Heritage Preservation Commission

Item: 5.A.

Item Name: 262 Lake Street - Amendment to Site Alteration Permit (HPC No. 2025-13)

KALORAMA COTTAGE ADDITION
AND REMODEL
262 LAKE STREET EXCELSIOR, MN 55331

OWNER:
ATTN: TROY MATHWIG
MAIL: 262 LAKE STREET
EXCELSIOR, MN 55331
PHONE : 612-275-0808
EMAIL: troy@4125llc.com

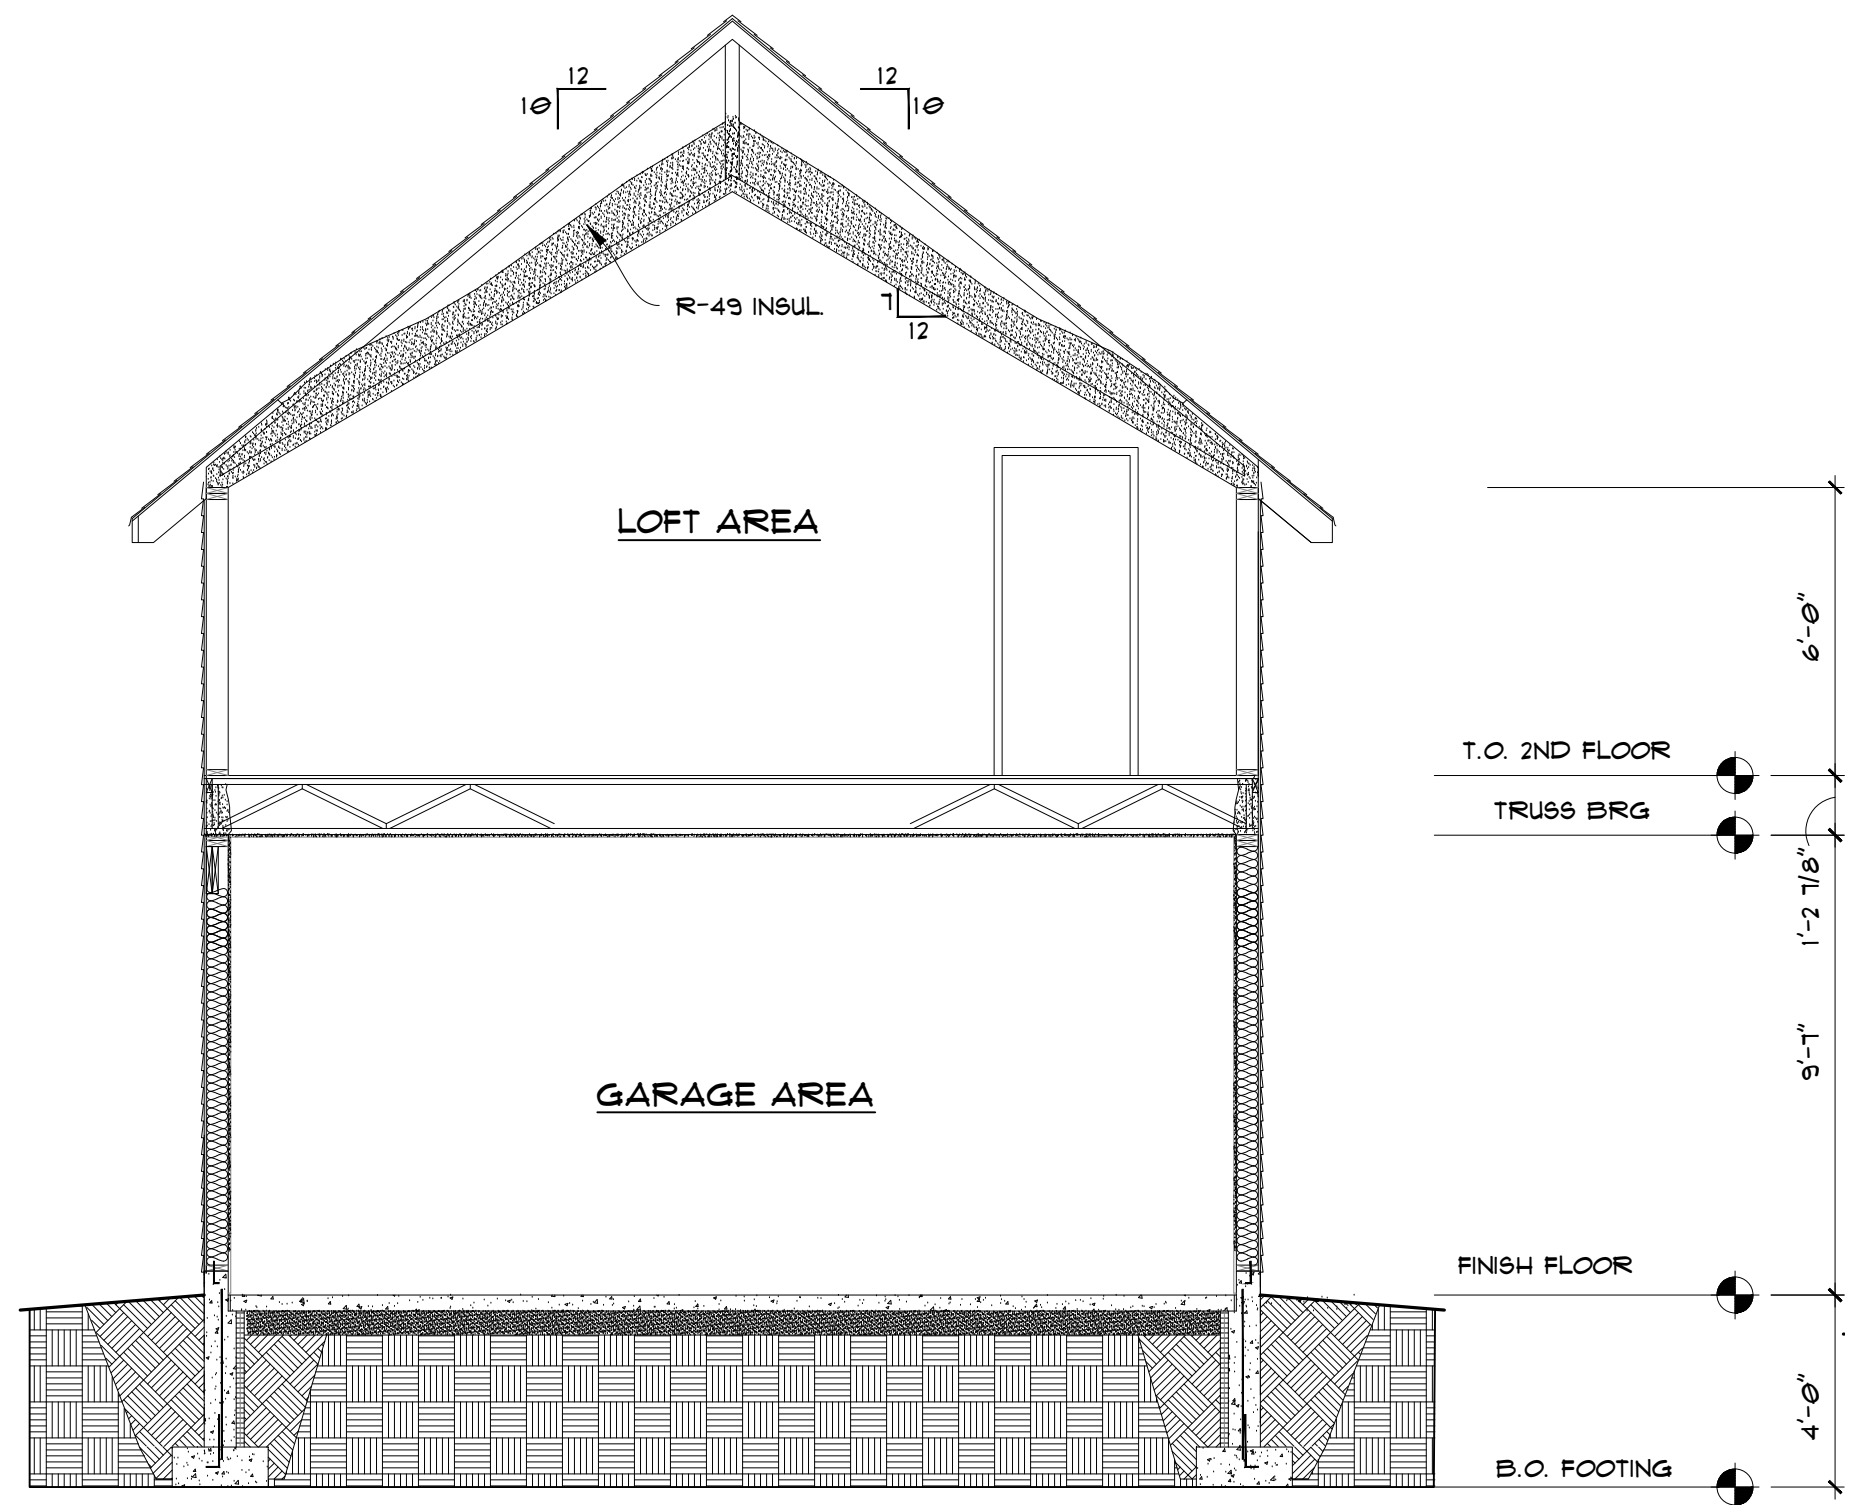
2. The garage height is different from approved plans. The garage height was approved for 24'8" (measured from grade) and is currently 27' at the ridge (measured from grade). Plans approved by the Heritage Preservation Commission (HPC) indicated 24'8"; plans with building permit showed 24'8" and 26'.

The construction plans, A501, describing how to build the garage did have a total height of 26’ 10”. The garage was built according to the plan. The total height is 26’. We dropped the height inside the garage by 10” to reduce the over-all garage height. We now have minimal clearance inside the garage for an opener, etc.
